SUBJECT: Contract No. 8496
NSC – BNSF Railway Structures/Realignment
FA Project No: Tiger4-0395(100)

**CHANGE ORDER TRANSMITTAL
CHANGE ORDER NO 14**

This change order compensates the Contractor for revisions made to Retaining Wall 6 in order to meet BNSF and AREMA requirements.

CONTRACT NO: 008496 FEDERAL AID NO: TIGER4-0395(100)
CONTRACT TITLE: US 395, NSC - BNSF RAILWAY STRUCTURES/REALIGNMENT
CHANGE ORDER NO: 14 BNSF RTW6 REVISION

RTW6 WALL
PLAN AND ELEVATION 1 OF 3

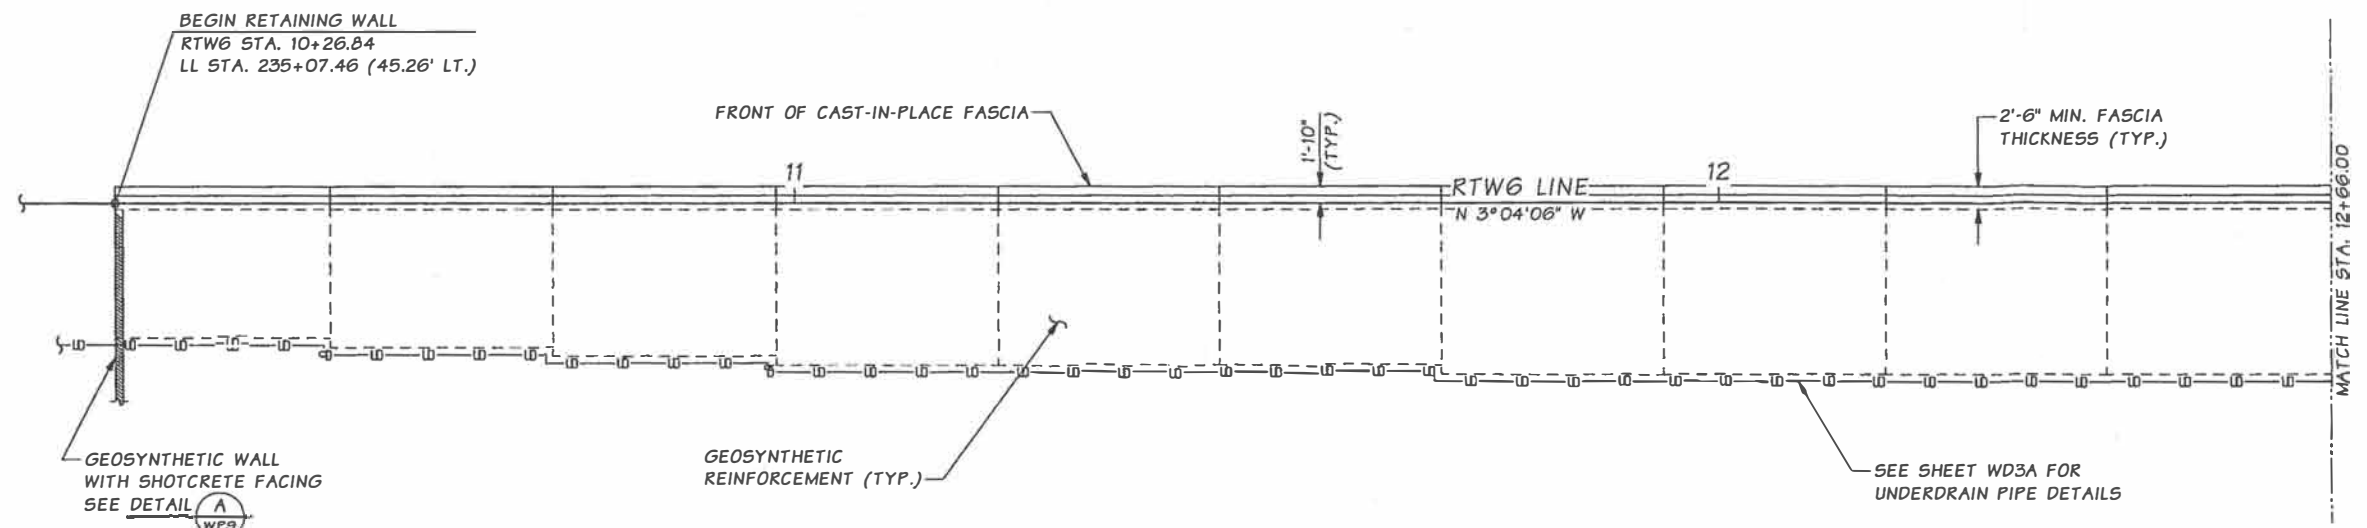
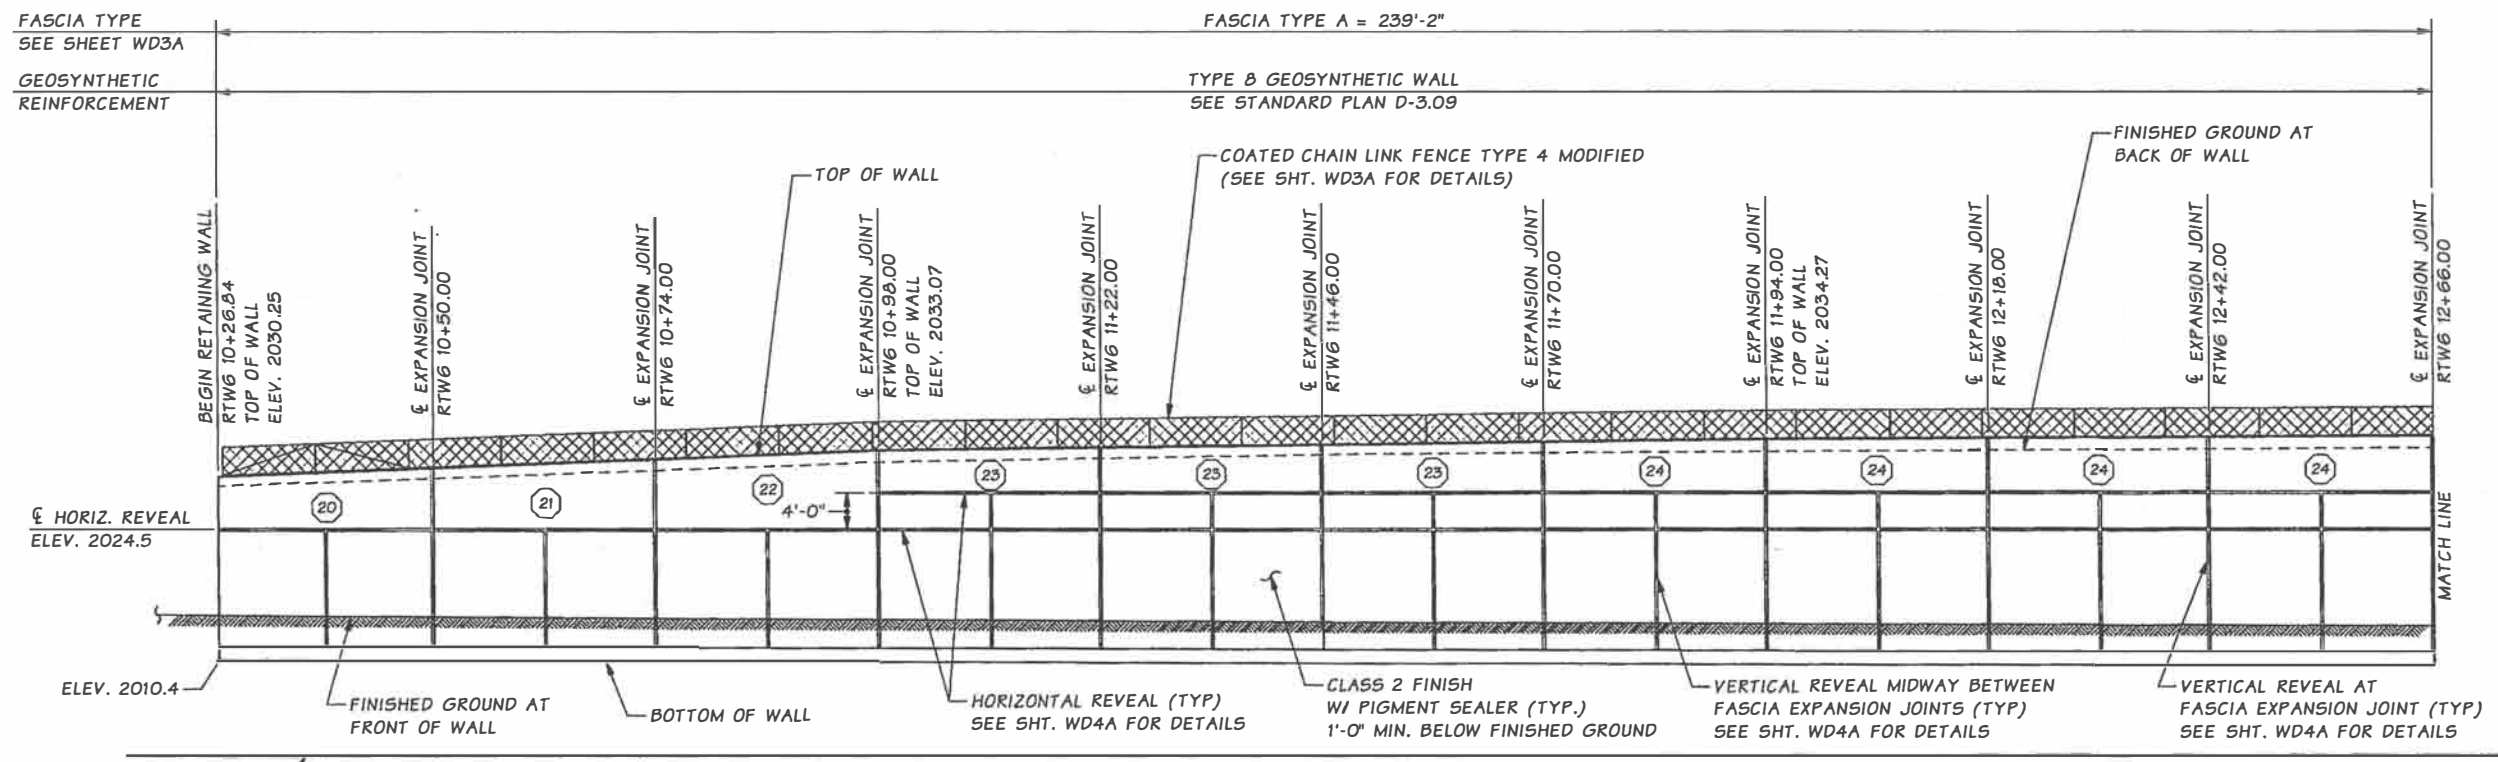
Contract Plan sheets 97 thru 99, 112, 113 and 119 of 376 are replaced with pages 5 through 10 of the change order.

Details "RTW6 Plan" and "RTW6 Elevation" are deleted from sheet 100 of 376; "Detail D", "Section E", and "Section F" are deleted from sheet 121 of 376.

The Contractor shall complete the Work as per pages 5 through 10 of the change order.

RTW6 WALL DETAILS 1 OF 3

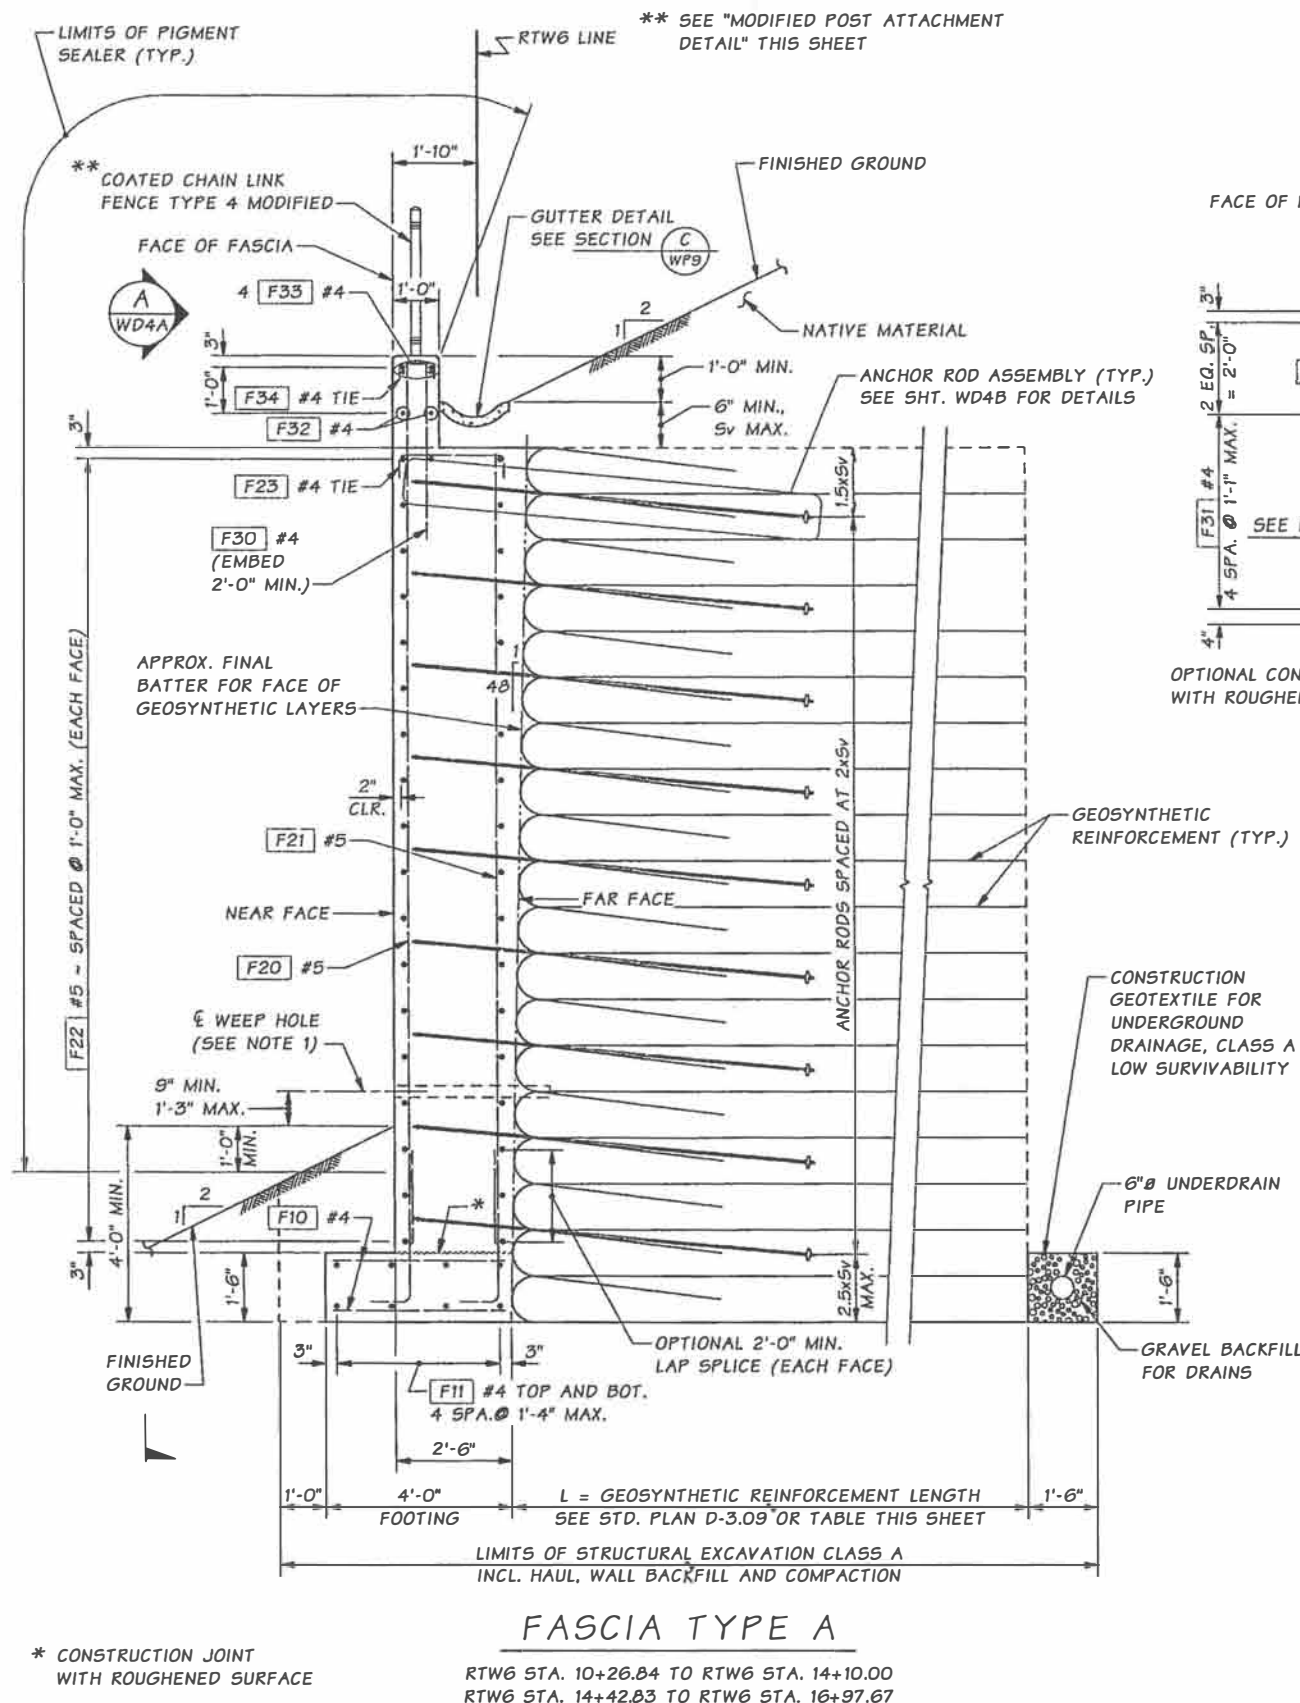
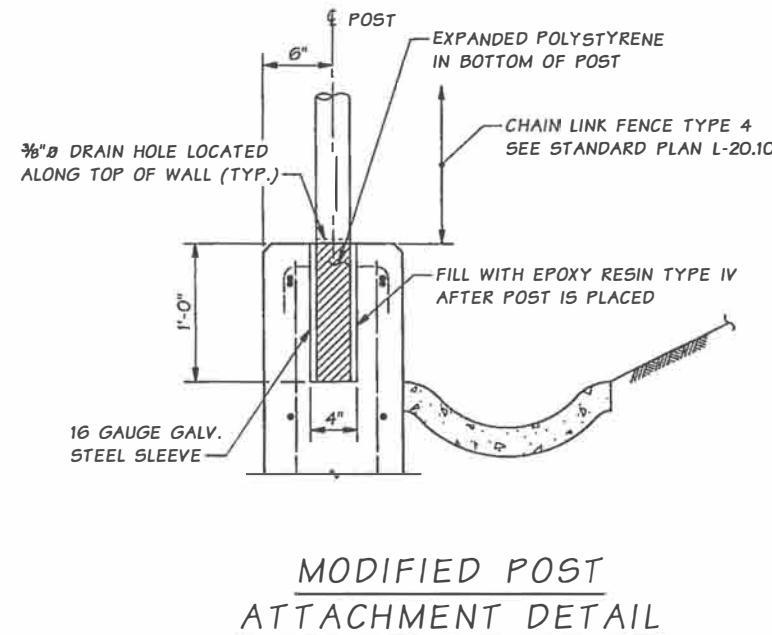
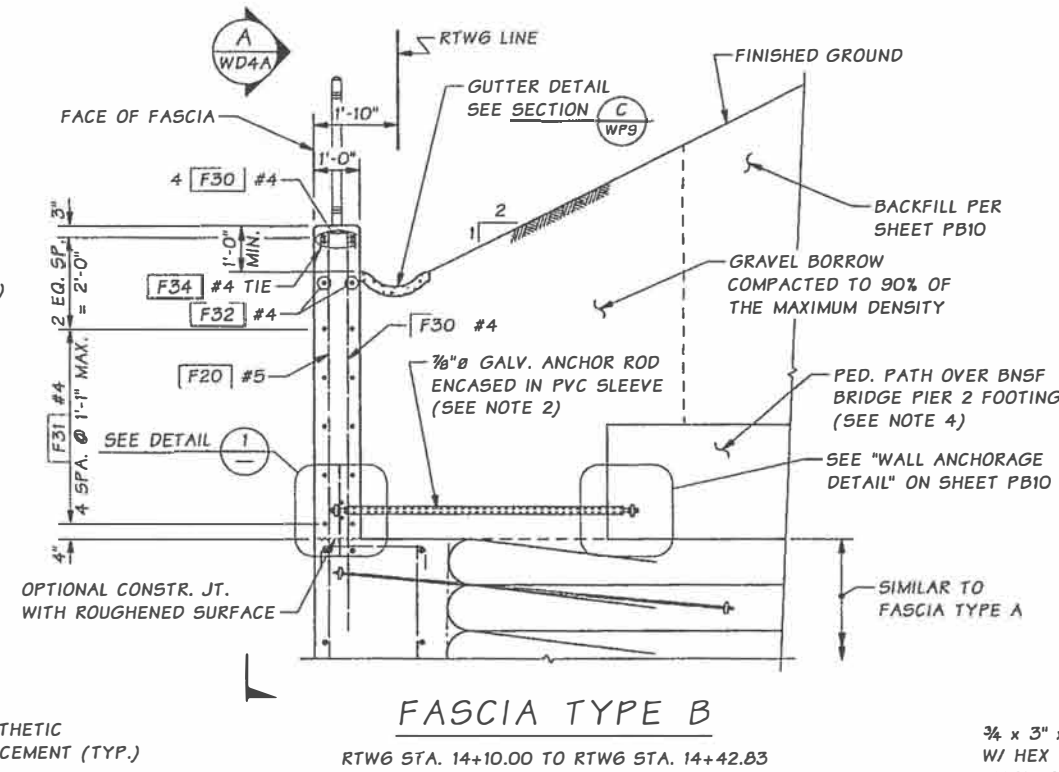
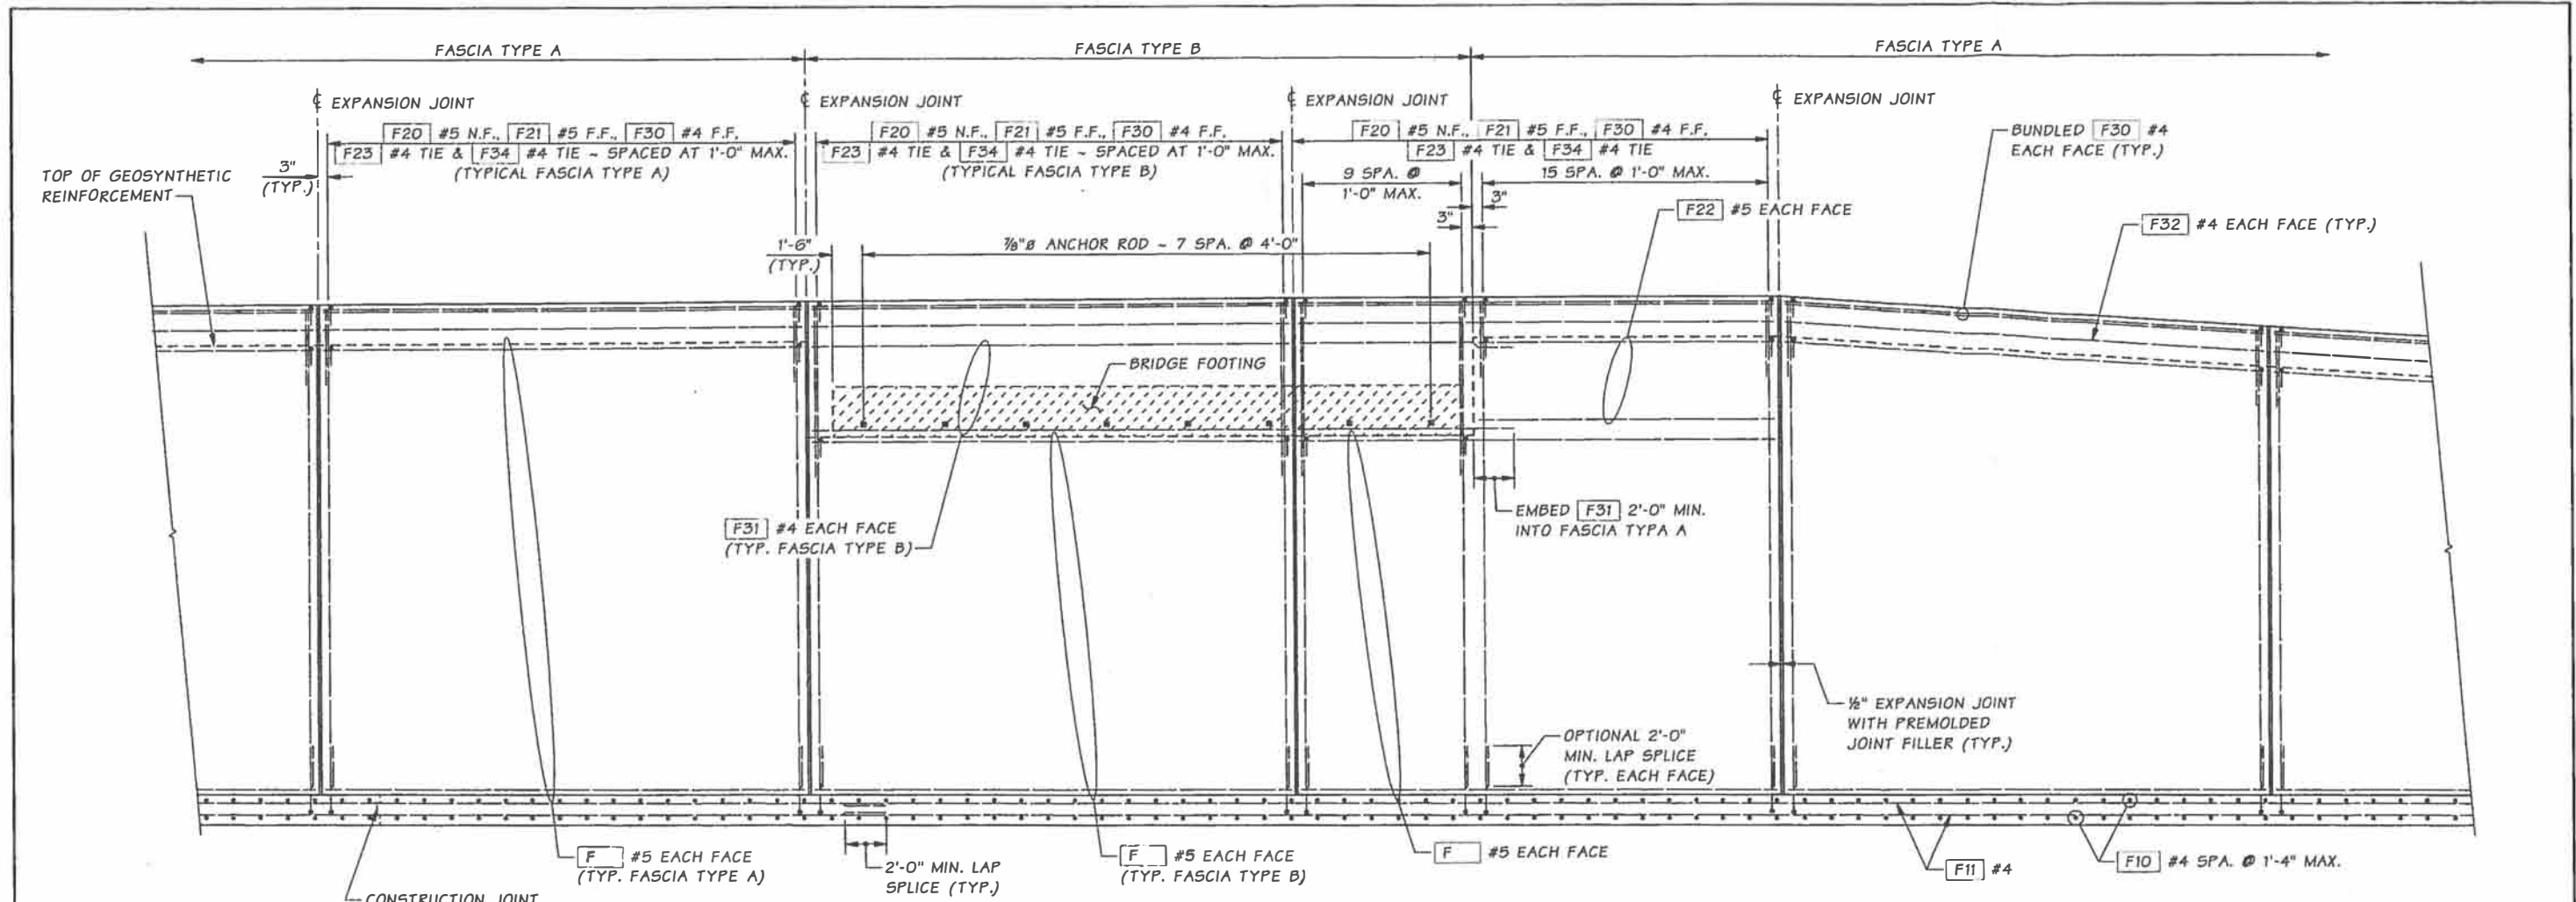
On sheet 323 of 376, note under "Stage 4" title revised from "Build Wall 6 to Final Height & Construct Wall 6 Fascia" to "See Wall 6 Plans for Remaining Pier 2 Construction Sequence". On sheet 330 of 376, references under "Wall Anchorage Detail" revised from "WD3 and WD4" to "WD3A and WD4A".
